Access Compliance Report

Public Rights-of-Way

(Curb Ramps)

Intersection ID: 47899	Main Street: PIERSON_DR	Cross Street: E_INDEPENDENCE_BV/PIERSON_DR_RA	Location: W
ADA ID: 3B2F75C0606A	Ramp Type: Perp	Initial Pass/Fail: Fail	Overall Compliance: No
Severity Score: 21.25			
Codes/Mitigation Info/Possible Solution		Field Measurements/Component Compliance

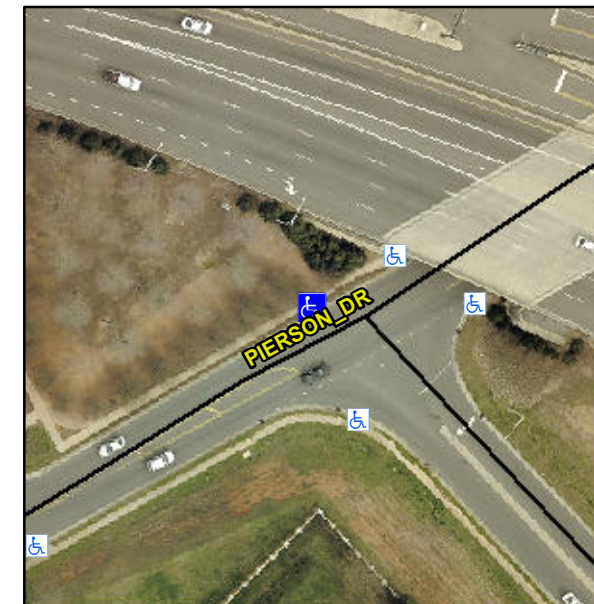
Not Found, R304.5.1, R304.2.2

Compliance	Description	Data	Compliance	Description	Data
N/A	Ramp Length (in)	84.0	No	Ramp Slope (%)	8.8
No	Ramp Width (in)	40.5	Yes	Ramp XSlope (%)	0.1
N/A	Flare Type LT	N/A	N/A	Flare Type RT	N/A
N/A	Flare Slope LT (%)	N/A	N/A	Flare Slope RT (%)	N/A
N/A	Flare Traversable LT?	N/A	N/A	Flare Traversable RT?	N/A
N/A	Landing Length (in)	N/A	N/A	DWS Provided?	N/A
N/A	Landing Width (in)	N/A	N/A	DWS Contrast?	N/A
N/A	Landing Slope (%)	N/A	N/A	DWS Length (in)	N/A
N/A	Landing X Slope (%)	N/A	N/A	DWS Full Width?	N/A
N/A	Landing Curb? (Y/N)	N/A	N/A	DWS Offset (in)	N/A
N/A	Shared Landing?	N/A			
N/A	Gutter Ponding?	N/A	N/A	Gutter Slope (%)	N/A
N/A	Gutter Lip Ht (in)	N/A	N/A	Gutter X Slope (%)	N/A
N/A	Painted X Walk1?	No	N/A	Painted X Walk2?	N/A
	X Walk 1 Direction	To S		X Walk 2 Direction	N/A
N/A	X Walk 1 Width (in)	N/A	N/A	X Walk 2 Width (in)	N/A
	X Walk 1 Slope (%)	0.0		X Walk 2 Slope (%)	N/A
	X Walk 1 X Slope (%)	0.8		X Walk 2 X Slope (%)	N/A

Remove & Replace Entire Ramp.
